Access Compliance Report

Intersection ID: 2770	Main Street: BELL'S MILL DR	Cross Street: TARLAND LN	Location: SE
ADA ID: 56F9F1FFA5BD	Ramp Type: PerpDiag	Initial Pass/Fail: Pass	Overall Compliance: No
Severity Score: 14.25			
Codes/Mitigation Info/Possible Solution		Field Measurements/Component Compliance

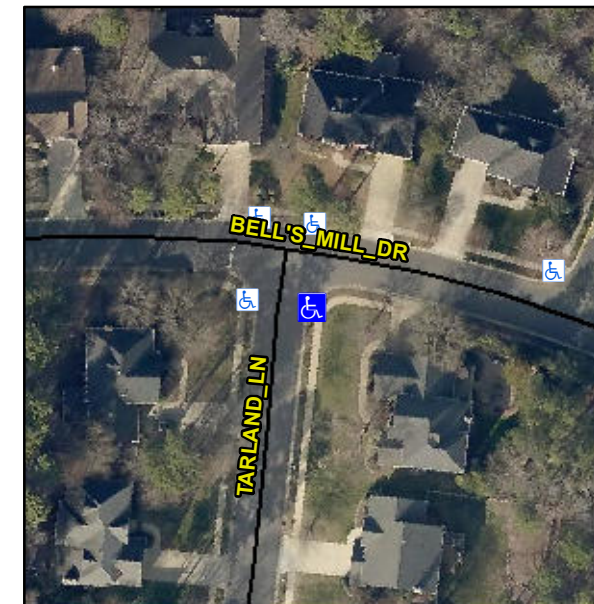
Not Found, R304.5.3, R304.2.1, R305.1.4, R305.2, R302.7.2

Compliance	Description	Data	Compliance	Description	Data
N/A	Ramp Length (in)	48.0	Yes	Ramp Slope (%)	6.5
Yes	Ramp Width (in)	66.0	No	Ramp XSlope (%)	3.4
N/A	Flare Type LT	Sloped	N/A	Flare Type RT	N/A
N/A	Flare Slope LT (%)	4.4	N/A	Flare Slope RT (%)	4.0
N/A	Flare Traversable LT?	No	N/A	Flare Traversable RT?	No
No	Landing Length (in)	47.0	Yes	DWS Provided?	Yes
No	Landing Width (in)	43.0	Yes	DWS Contrast?	Yes
Yes	Landing Slope (%)	0.1	Yes	DWS Length (in)	25.5
No	Landing X Slope (%)	4.0	No	DWS Full Width?	No
N/A	Landing Curb? (Y/N)	No	No	DWS Offset (in)	2.5
N/A	Shared Landing?	No			
Yes	Gutter Ponding?	No	Yes	Gutter Slope (%)	3.9
No	Gutter Lip Ht (in)	0.3	No	Gutter X Slope (%)	3.1
N/A	Painted X Walk1?	No	N/A	Painted X Walk2?	No
	X Walk 1 Direction	To W		X Walk 2 Direction	To N
N/A	X Walk 1 Width (in)	N/A	N/A	X Walk 2 Width (in)	N/A
	X Walk 1 Slope (%)	3.2		X Walk 2 Slope (%)	4.9
	X Walk 1 X Slope (%)	2.7		X Walk 2 X Slope (%)	4.7

Remove & Replace Curb Ramp With Two New Directional Ramps or Equivalent. Remove & Replace Gutter.
